RECORD DRAWING
 This drawing represents the final version of information supplied by Powell Dobson Architects to the contractor, plus any site changes advised by the contractor.

BLOCK 3

Contract: **Barratt North London
 Comet Square Phase II, Hatfield**

Drawing No. Rev.
 G2120 B3(20) 207 J

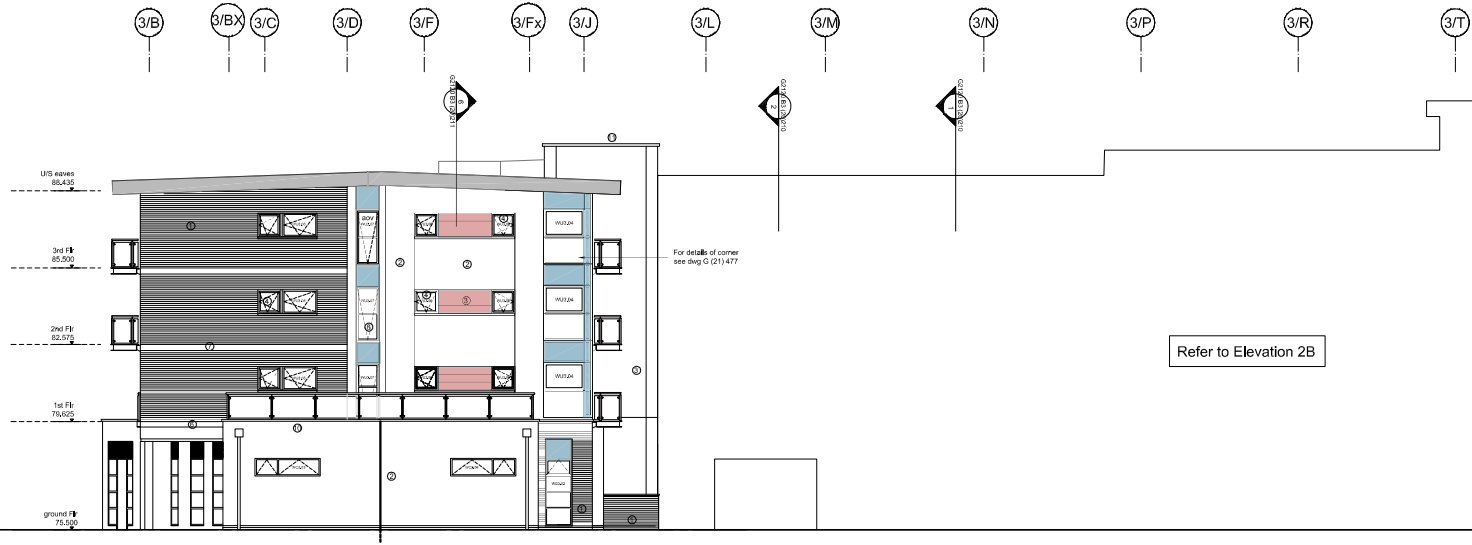
Revisions:			
A	09.01.06	of	Creche bin store door relocated to elevation 2A following redesign as SD comments 19.10.2005, Mtd transome omitted to balcony screens, Balconies and windows adjusted to match plans, Creche window configuration corrected, Balcony design changed to pre-fabricated metal units, render panels behind balconies changed to brickwork, Adjacent panels changed as appropriate (see minutes of meeting on 15.12.05)
B	16.02.06	cht	Privacy walls updated to show metal cladding. - Issued to planning (see letter of 16th Feb 2006).
C	23.02.06	af	First floor balconies overlooking Play Areas amended to 'Juliette' - Issued to planning (see letter of 23rd Feb 2006).
D	28.02.06	cht	Movement joints added and section lines amended.
E	24.07.06	cht	Window numbers added, Cladding joints between windows revised, Fire mains box added RWPP relocated to suit, Ground floor elevations amended in accordance with Scrumville Design fax. Fixed pane to window WU3.06 replaced with tilt & turn, Cladding reference notes added.

F	12.06.06	cht	Fourth floor level note corrected.
G	26.02.07	AF	Cladding joints revised to suit construction detailing as instructed by ENL.
H	11.06.07	CKC	Record Drawing Issue.
J	19.11.07	AF	Extents of shopfront canopies revised to suit proposed shopfront layouts provided by tenants
